277-289 WOODPARK ROAD SMITHFIELD NSW 2164

CIVIL WORKS

AMENDED PLAN

ALS
SMITHFIELD REDEVELOPMENT APPLICATION
277-289 WOODPARK ROAD SMITHFIELD LOT 1 IN DP1024505
COVER SHEET, DRAWING LIST
AND LOCALITY PLAN
CALIBRE DRG No.
COPP20170-DWG-C-0000
CLIENT DRG No.

ALS
SMITHFIELD REDEVELOPMENT APPLICATION
277-289 WOODPARK ROAD SMITHFIELD LOT 1 IN DP1024505
STORMWATER CATCHMENT PLAN
CALIBRE DRG No.
COPP20170-DWG-C-0460
CLIENT DRG No.
REV
D

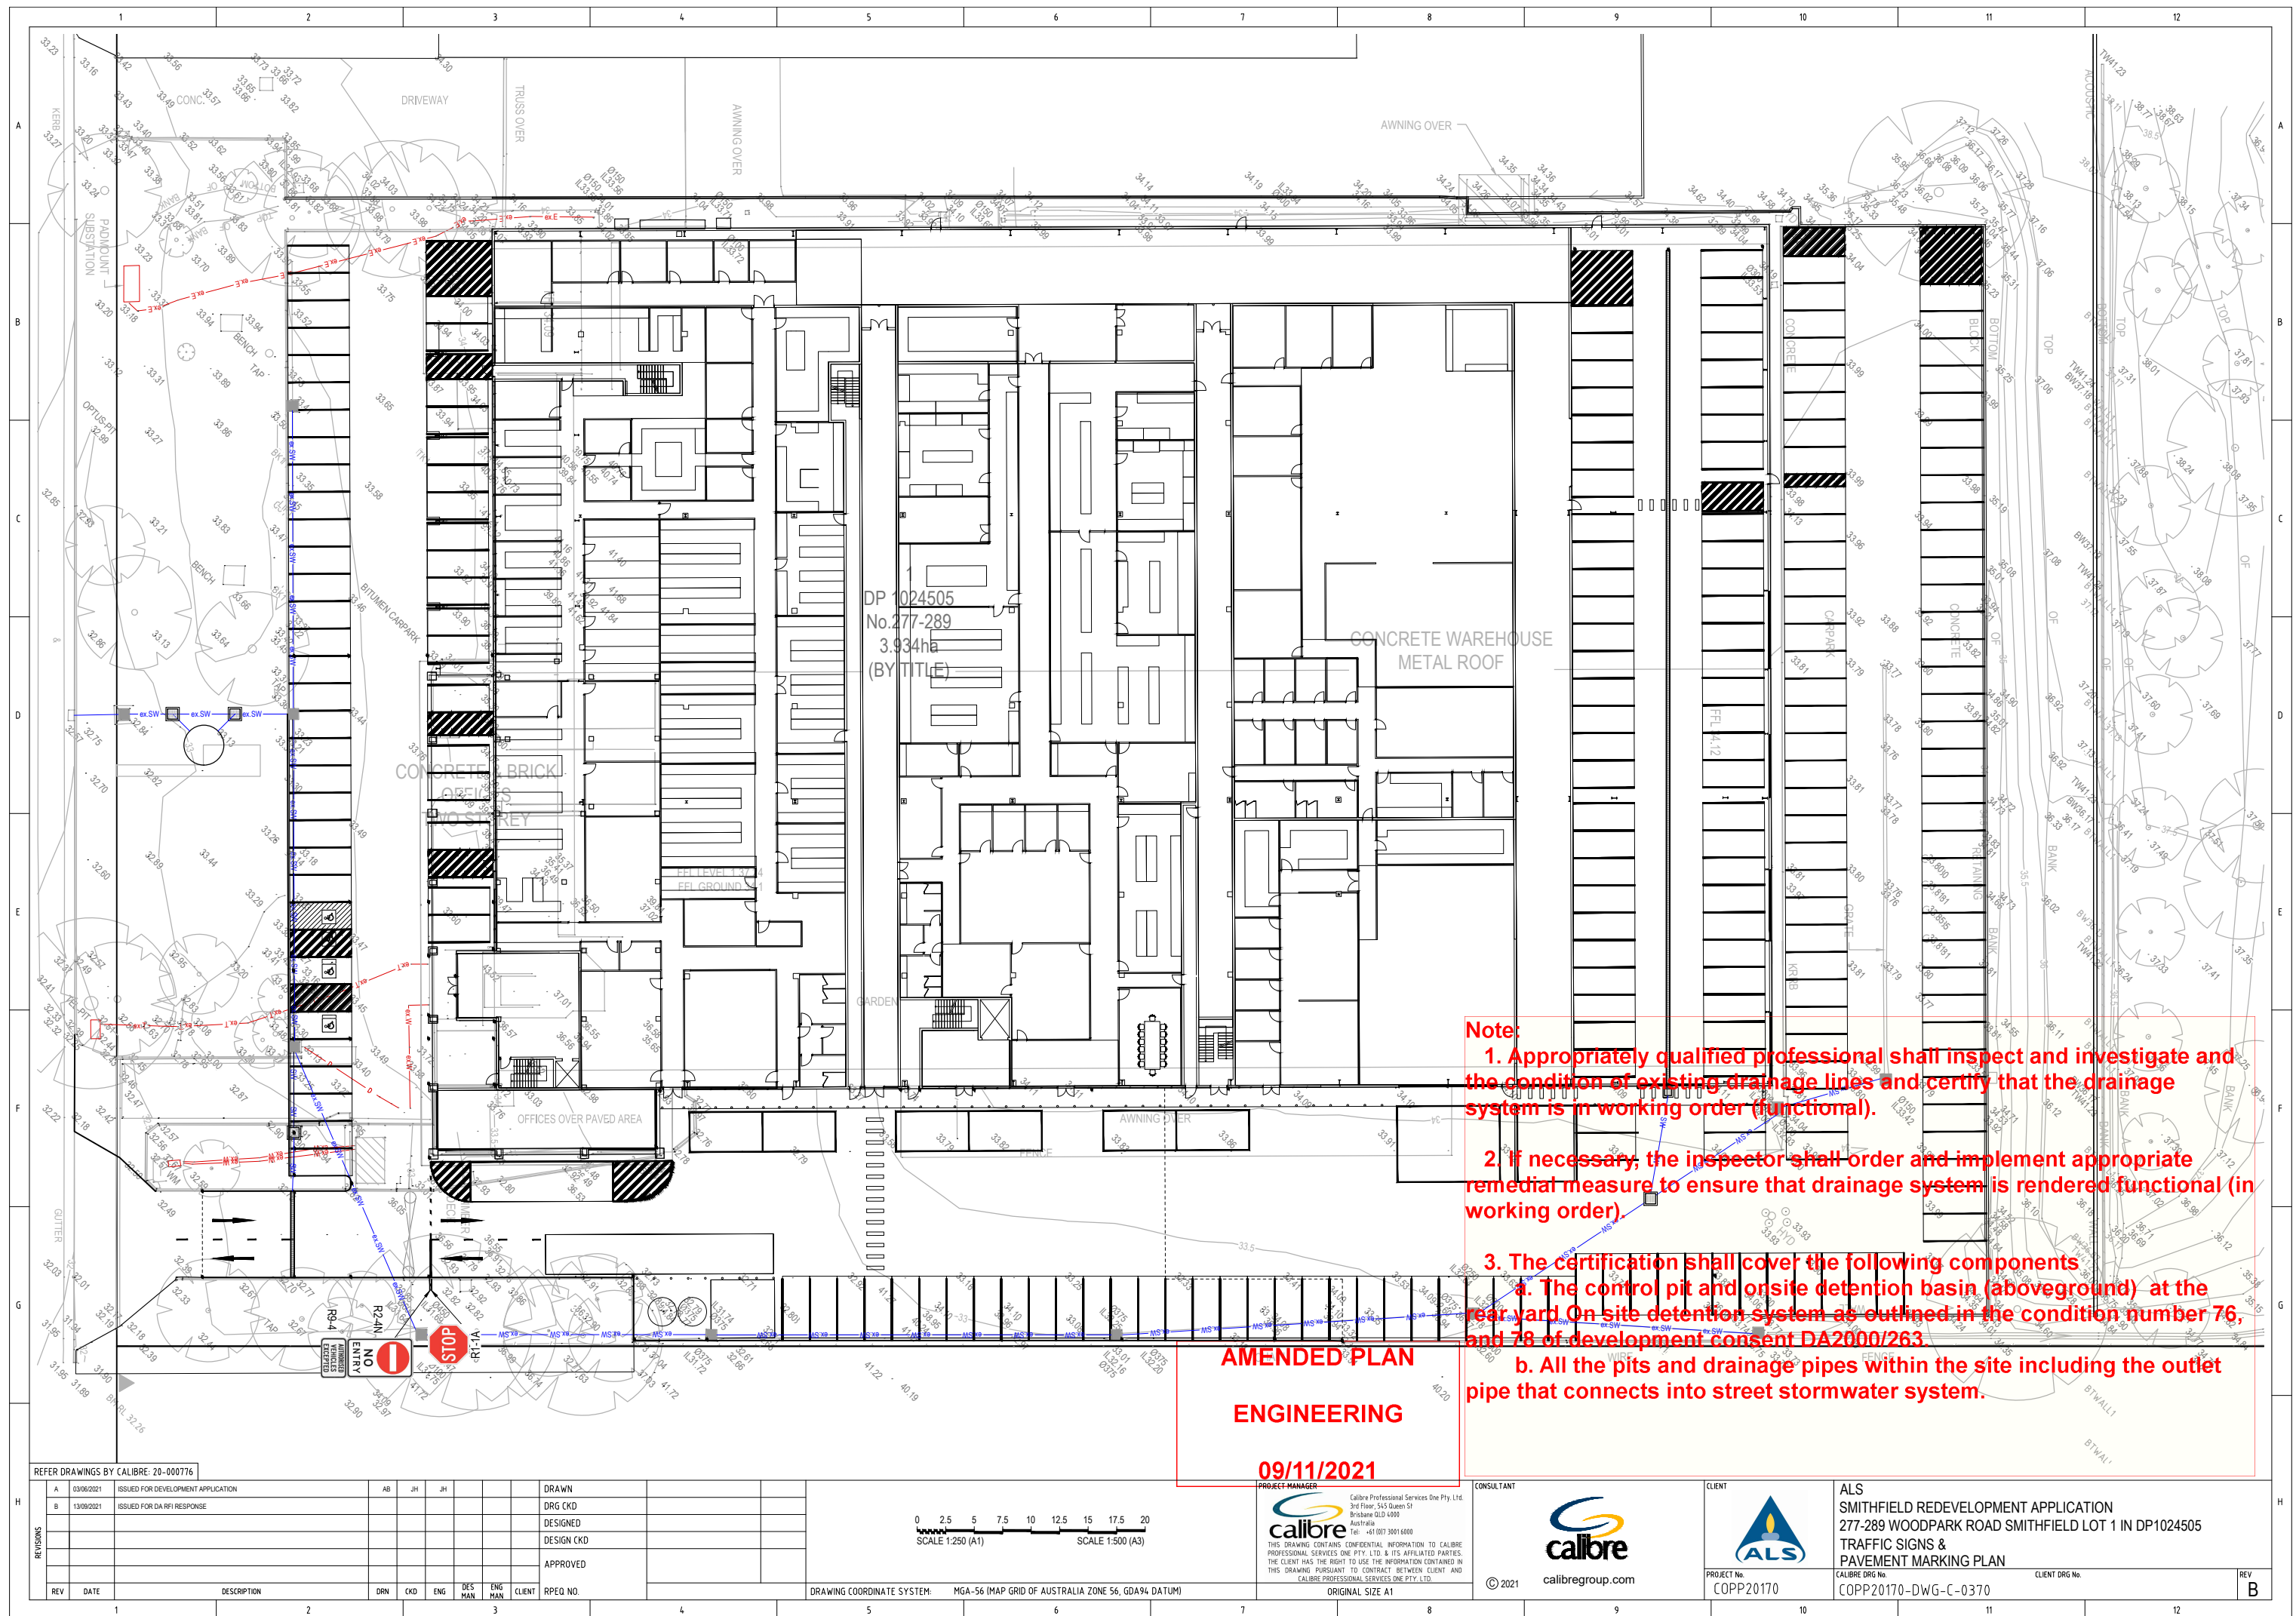
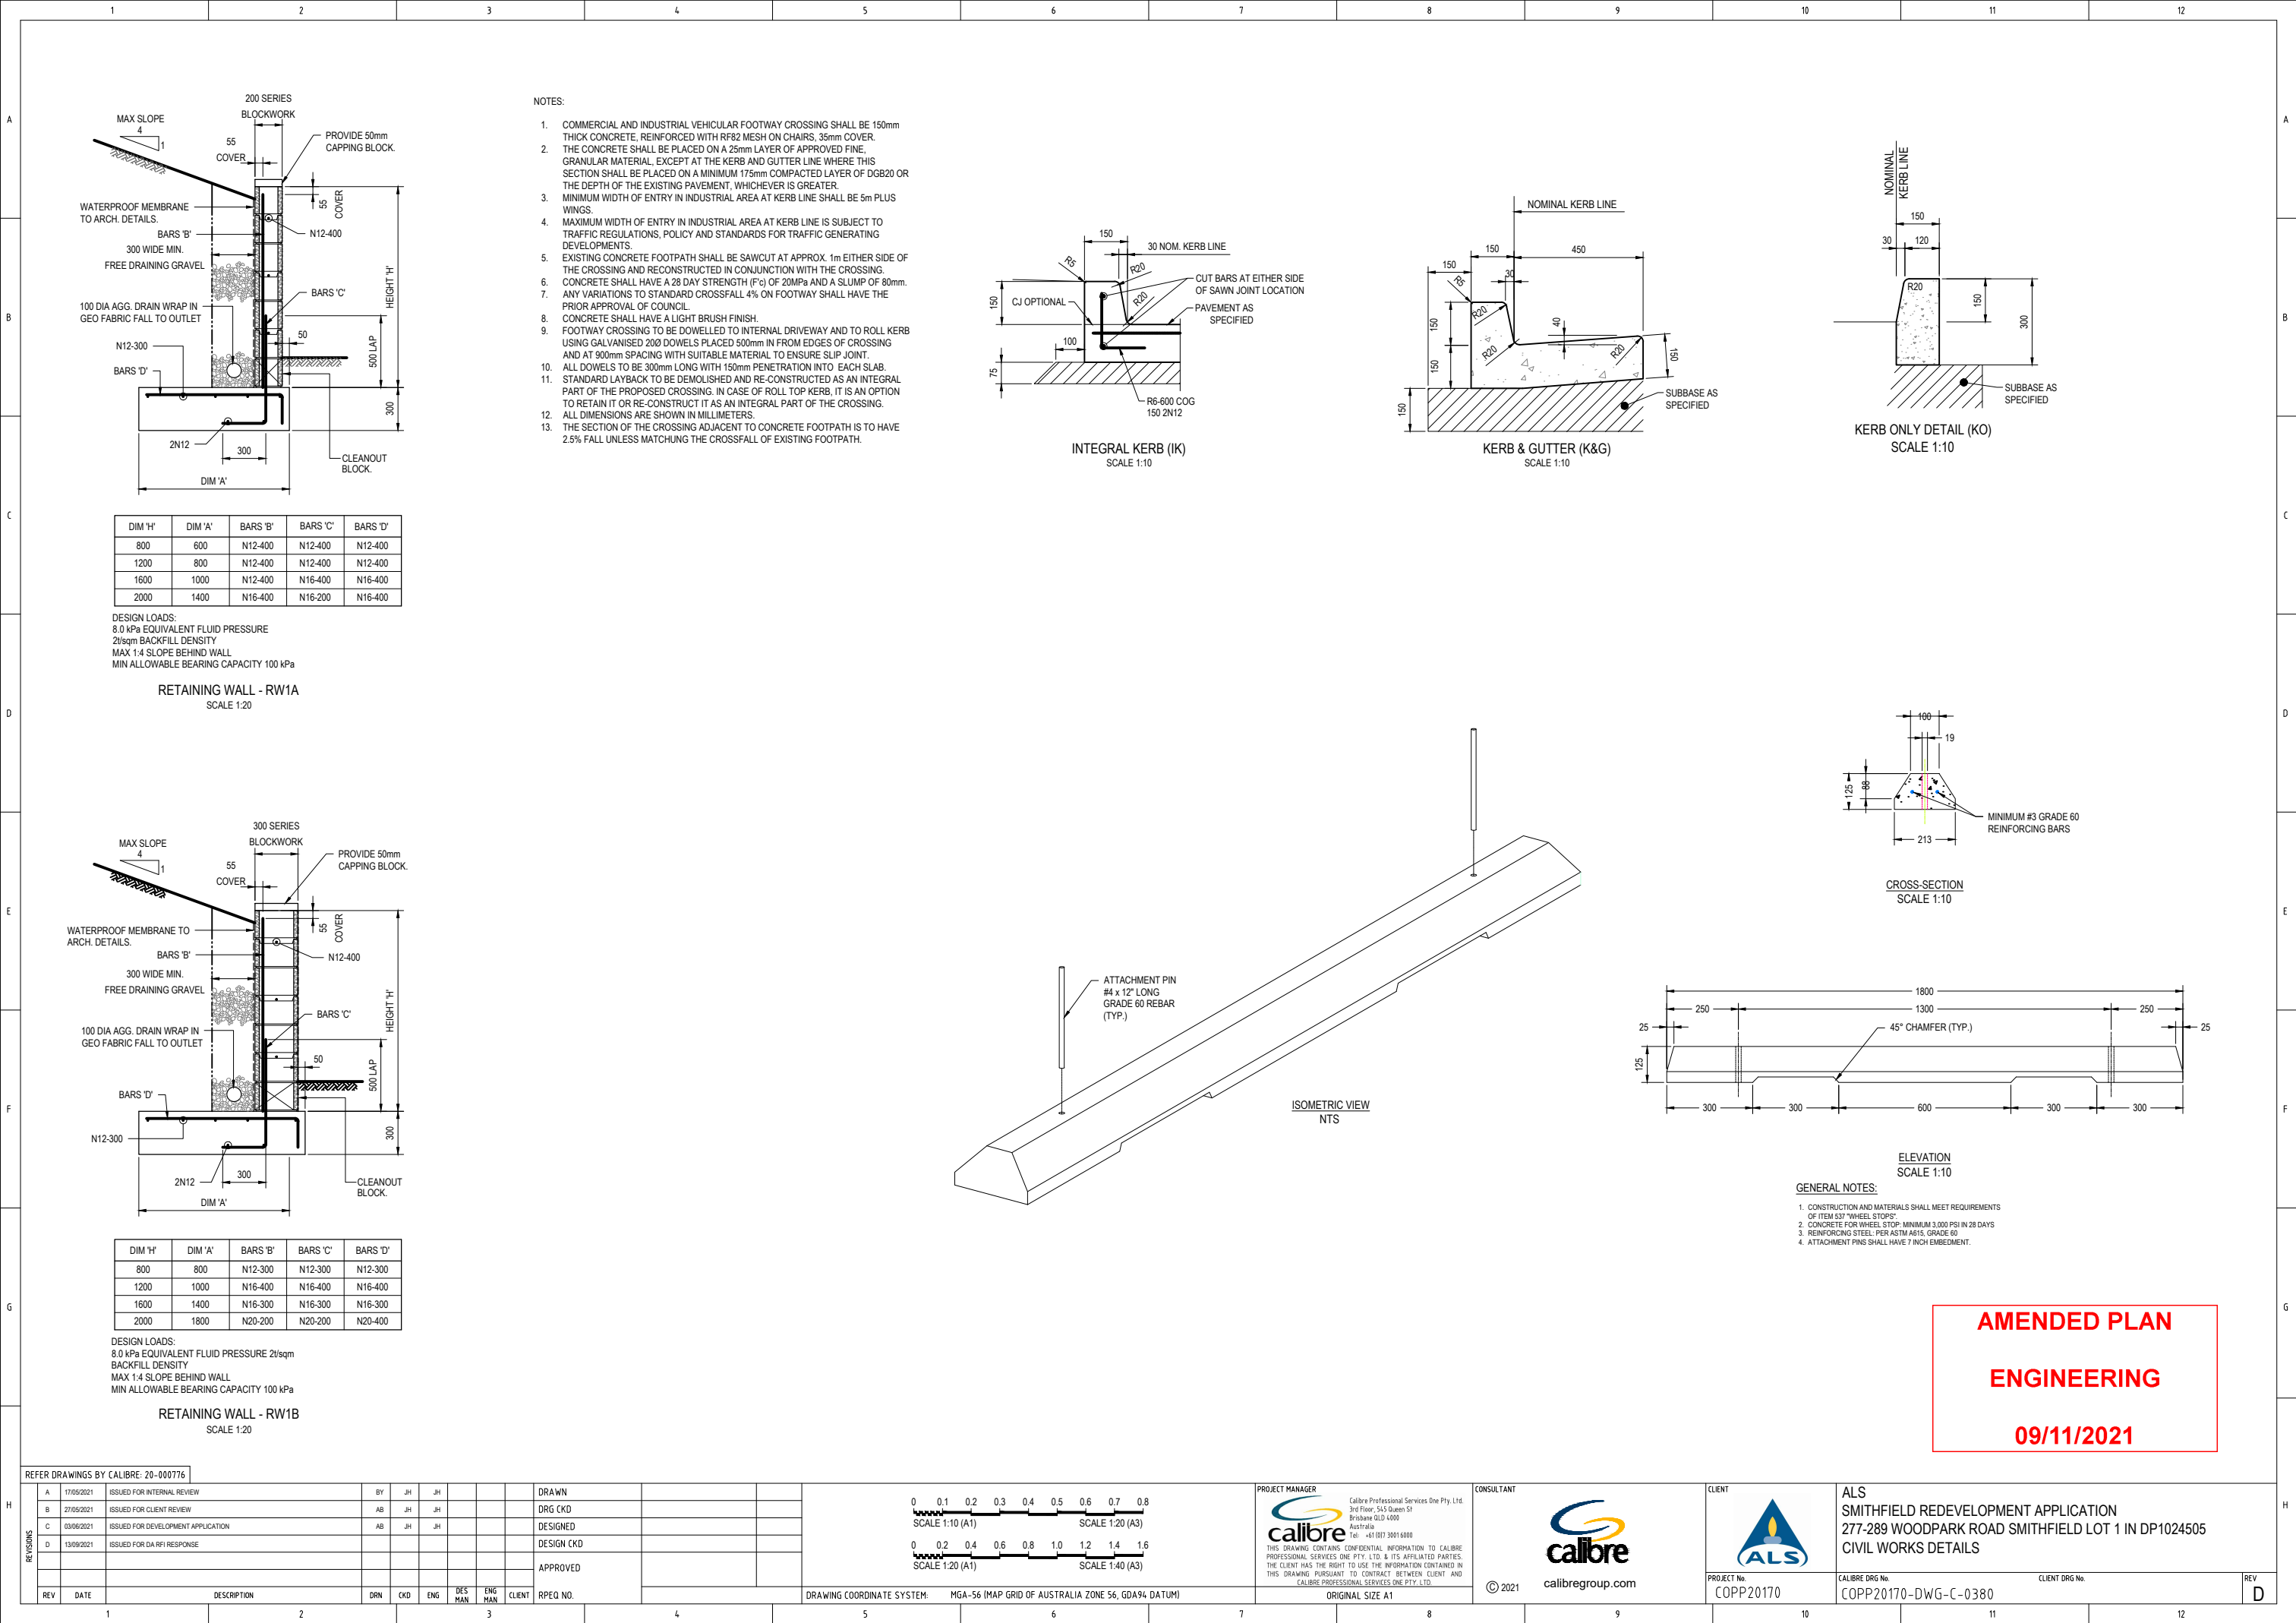
- Note:**
1. Appropriately qualified professional shall inspect and investigate and the condition of existing drainage lines and certify that the drainage system is in working order (functional).
 2. If necessary, the inspector shall order and implement appropriate remedial measure to ensure that drainage system is rendered functional (in working order).
 3. The certification shall cover the following components
 - a. The control pit and onsite detention basin (aboveground) at the rear yard On site detention system as outlined in the condition number 76, and 78 of development consent DA2000/263.
 - b. All the pits and drainage pipes within the site including the outlet pipe that connects into street stormwater system.

NOTE:
PROVIDE OCEANGUARD PIT BASKETS IN
ALL GRATED PITS DRAINING PAVEMENT
OR REAR LANDSCAPE AREAS
